118 BERTIE STREET, PORT MELBOURNE (5/2016/MIN/A)

1. PURPOSE

- 1.1 To provide a Council position for the Fishermans Bend Standing Advisory Committee on the request from the Minister for Planning to prepare, adopt and approve an Amendment to the Planning Scheme under Section 20(4) of the Planning and Environment Act for 118 Bertie Street, Port Melbourne.

Figure 7. Extract of Map 2 of DDO32 showing the 12-storey height area in **red**, and non-specified height area in **blue**, and propose public open space in **green**. The subject site boundaries are shown **orange**.

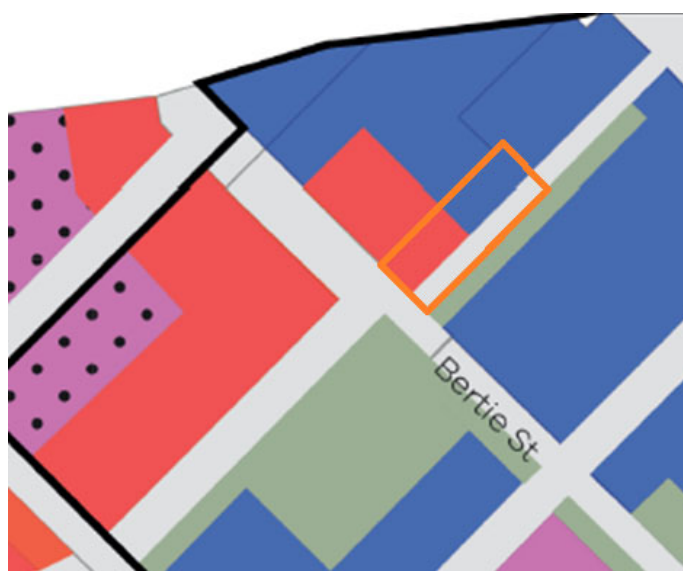
11.4-4 The building now proposed has a 20-storey built form, which would be two storeys and 8.2m higher than the previous built form called in by the Minister. As part of the site (after the Gazettal of Planning Scheme Amendment GC81) is now in an area designated under the DDO32 as having a discretionary maximum height of 12 metres a portion of the proposed 20 storey tower will likely fall within this reduced height portion of the land, therefore failing to comply. The remainder of the lot is within an area with no height restriction therefore only a small portion of this built form would be non-compliant.

- 11.4-5 The 12 storey (43m) height limit is located over the Bertie Street portion of the site, and is intended to reduce the visual bulk, and shadowing impacts from any proposed built form onto the public realm of Bertie Street and the future public park to the south-west of the subject site. The built form sets back the tower portion 26.7 metres from the front boundary of the site, almost 3 times the preferred setback stipulated under the DDO32.

Figure 8: Extent of shadow at 11am on 22 September equinox. (Dark grey shading = proposed extent of shadow. Blue outline = shadow that would be cast by the planning envelope specified under the DDO32).

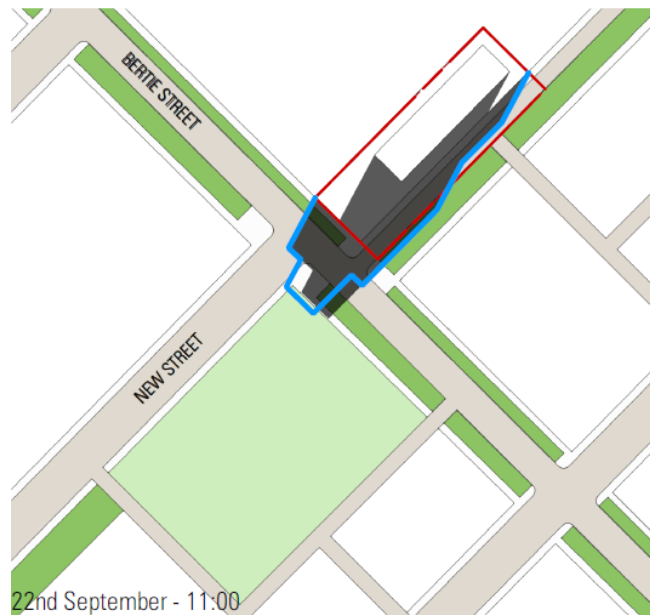
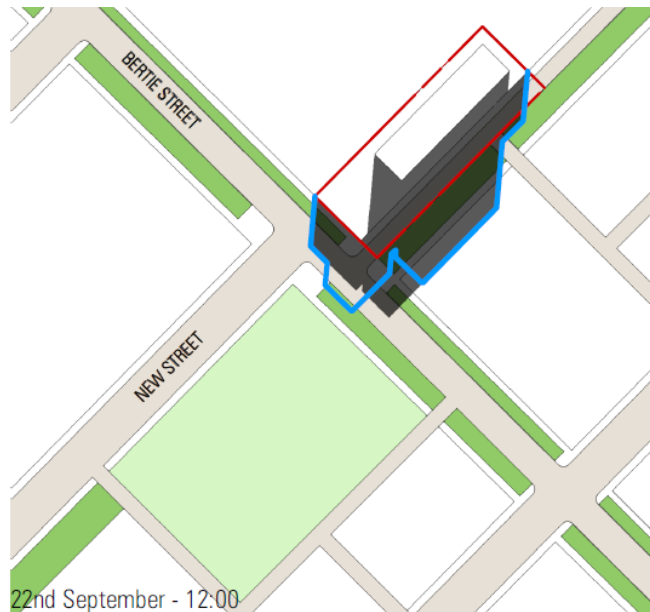
- 11.4-8 The Fishermans Bend Framework and the Planning Scheme stipulates the protection of the proposed and existing open spaces from impacts from surrounding developments, including from overshadowing.
- 11.4-9 DDO32 specifies the proposed park to the South-west of the subject site should not be overshadowed between 11.00am and 2.00pm on 22 September, however it should be noted that at the time of the original application, the shadow policy formed Objective 3.3, Guideline 4 of the Fisherman Bend Framework.
- 11.4-10 The proposed 26.7m setbacks of the tower portion of the built form to the Bertie Street (front) boundaries would increase the shadows cast compared to the current called in application. However, as demonstrated by the shadow diagrams at Figures 8 and 9, the extent of shadow on the proposed public open space would comply with this requirement.

11.4-7 Whilst the revised design would change the pattern of shadow falling onto the reserve at 11.00am, the new shadow still does not fall onto the protected portion of the public open space complying with the overshadowing requirement specified in Section 2.6 of the DDO32, and by an hour later at midday has retreated to covering only half of Bertie Street.

Figure 10. Extract of Map 2 of CCZ1, showing the proposed 12 metre roadway in red cross hatching.

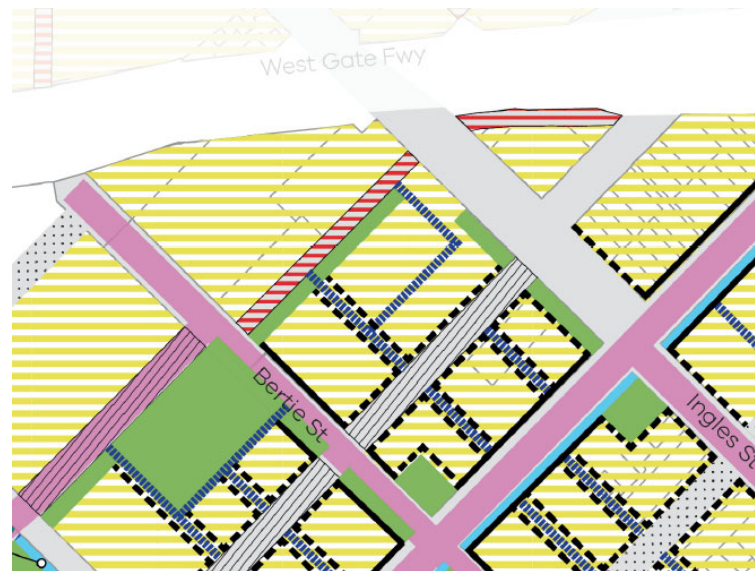
11.5-2 Map 2 (Sandridge Urban Structure) of Schedule 1 of the CCZ, as well as the Fisherman Bend Framework (October 2018) designates that a 12.0m wide new roadway is intended to run along the south-east boundary of the subject site to

create a thoroughfare from Bertie to Ingles Street, and will be abutted to its south-east by a lineal park.

11.5-3 The subject site is 3,031m² in area and under the current proposal only designates a 9.0 wide roadway, which as shown below facilitates a 6 metre wide road, with separate pedestrian path either side of a 1.5m width (or one pathway of 3.0m). The application states that the proposed allowance for a 9.0m wide roadway along the south eastern boundary will ensure that the intentions of the Fishermans Bend Framework are successfully implemented by providing an effective vehicular and pedestrian connection between Bertie and Ingles Street.

Figure 11: Demonstration of the ability to achieve a 6 metre wide two-way thoroughfare within the 9 metre roadway proposed by the applicant. South-east lot boundary shown in red.

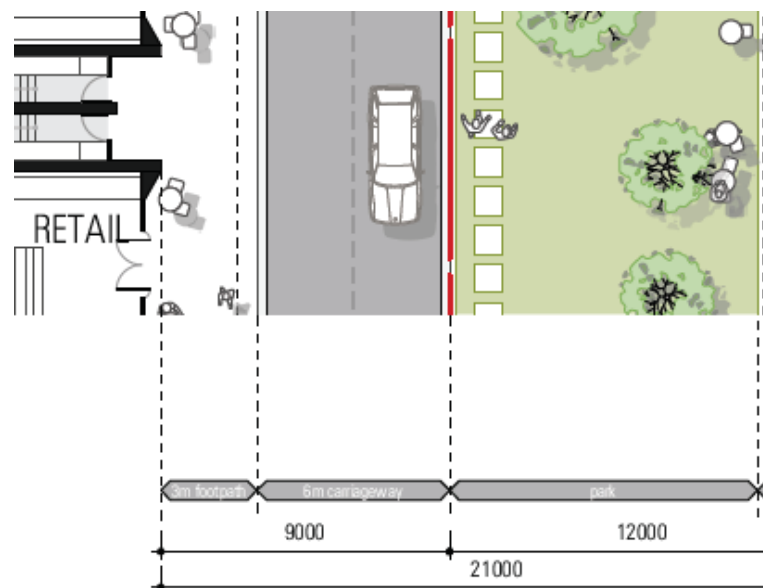
- 11.5-4 Given the constraints of the site due to its small size, and narrow width enforcing the provision of the full 12 metre extent for the new road, needs to be considered against the likely vehicular traffic that will eventually utilize the road and the effect, if any, of the reduced width of the road would have on its feasibility and usability as intended by the Fishermans Bend Framework.
